REGULATORY INFORMATION DISTRIBUTION SYSTEM (RIDS)

SUBJECT: Suppl to 790104 ltr re containment purging during normal
 plant operation. Requests continuation of review of Tech
 Spec change request for Unit 2 to permit unrestricted
 purging.

June 8, 1979
AEP:NRC:00114A

Donald C. Cook Nuclear Plant Units 1 and 2
Docket Nos. 50-315 and 50-316
License Nos. DPR-58 and DPR-74

FIGURE 1
DONALD C. COOK NUCLEAR PLANT UNITS 1 AND 2
TYPICAL ANNUNCIATOR CIRCUIT

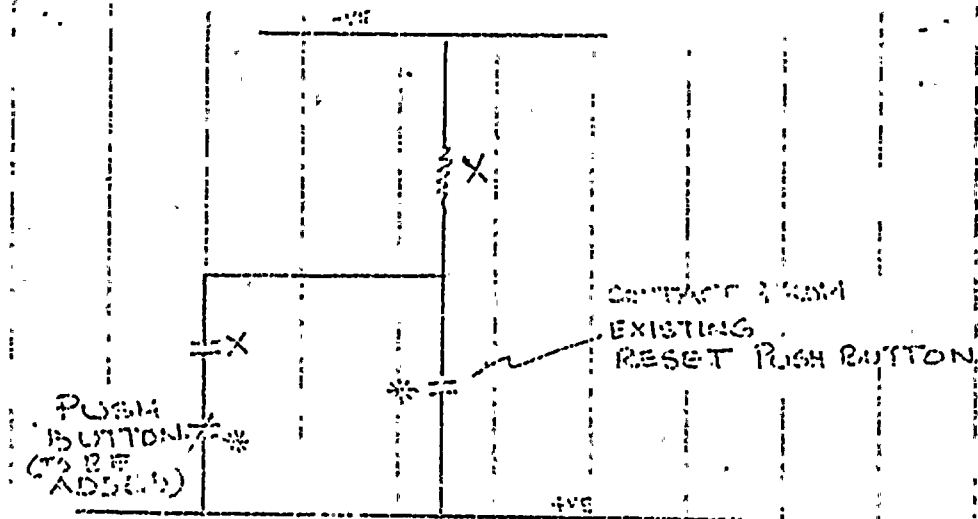
Alarming the reset (blocked) condition of any safeguards output signal will be accomplished by adding new circuits external to the Reactor Protection System. Operation of the reset switches (push buttons) to reset any of the safety actuation signals will annunciate

in the control room. Operator initiation of a safety actuation signal reset will be performed under the positive administrative controls described above in our response to Item 1. Use of the reset switch will place a reset signal into the Reactor Protection System and at the same time energize a relay causing the annunciator to alarm. This alarm will occur whether or not a trip initiating signal is present (i.e., whether or not safety actuation signals are blocked). As a conservative measure, the alarm will alert the operator that he is in the "blocked" condition for that particular safety function. This alarm will remain present until such time as deliberate operator action is taken to return this "blocked" indication to normal. This restoring action will be accomplished under administrative control. An evaluation of the status of the safety actuation signal inputs will be performed to make the determination that no real "blocked" condition exists and the reset signal in the Reactor Protection System has cleared. Manual operation of the alarm de-energizing circuit switch is required to restore the indication to normal. The "Reset (Blocked)" annunciators will be added to the following functions:

- 1) Containment Isolation - Phase A
- 2) Containment Isolation - Phase B
- 3) Containment Ventilation Isolation (CVI)
- 4) Containment Spray
- 5) Safety Injection
- 6) Feedwater Isolation

A schematic electrical diagram of a typical annunciator circuit is shown on Figure 1. This annunciator circuit will be installed prior to startup of Units 1 and 2 from their current shutdown mode. The alarm de-energizing reset switch will be covered by the sealed covers described in response to Item 1.

FIGURE 2
DONALD C. COOK NUCLEAR PLANT UNITS 1 AND 2
CONTAINMENT VENTILATION VALVE CIRCUIT MODIFICATIONS

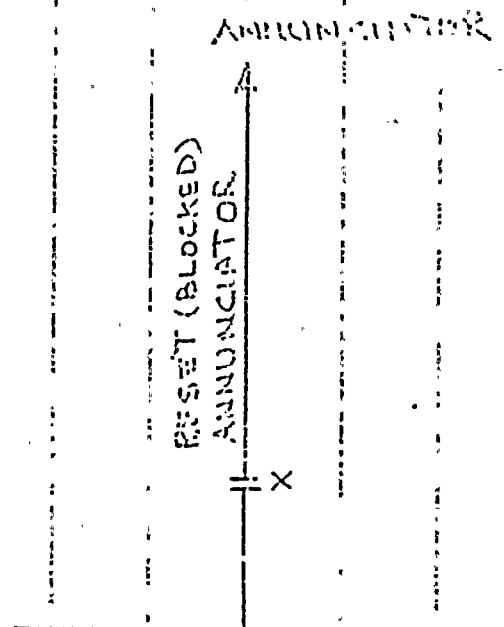
As indicated in our January 4, 1979 letter, if Containment Ventilation Isolation is reset with a trip initiating signal present, then all other automatic initiating signals are blocked from causing isolation. We plan to modify the circuit such that a Containment Phase A isolation signal will automatically isolate the Containment Ventilation System valves when "blocked" condition is present. Automatic initiation of Phase A isolation is caused by a Safety Injection signal derived from the Reactor Protection System or Containment Pressure-High at 1.2 psi.

The valves listed in Table 1 are presently actuated closed from a CVI signal. After the modification, these valves will also receive a trip close signal from a Containment Isolation - Phase A signal. This signal will directly trip the valves closed regardless of the condition of the CVI reset/block circuits. A schematic electrical diagram for a typical Containment Ventilation valve circuit modified to show this additional trip signal is presented in Figure 2. With this modification, CVI can be reset with a trip initiating signal present (blocked condition) and the valves re-opened by operation of the valve control switch. A subsequent Phase A Containment Isolation signal will automatically trip the valves closed.
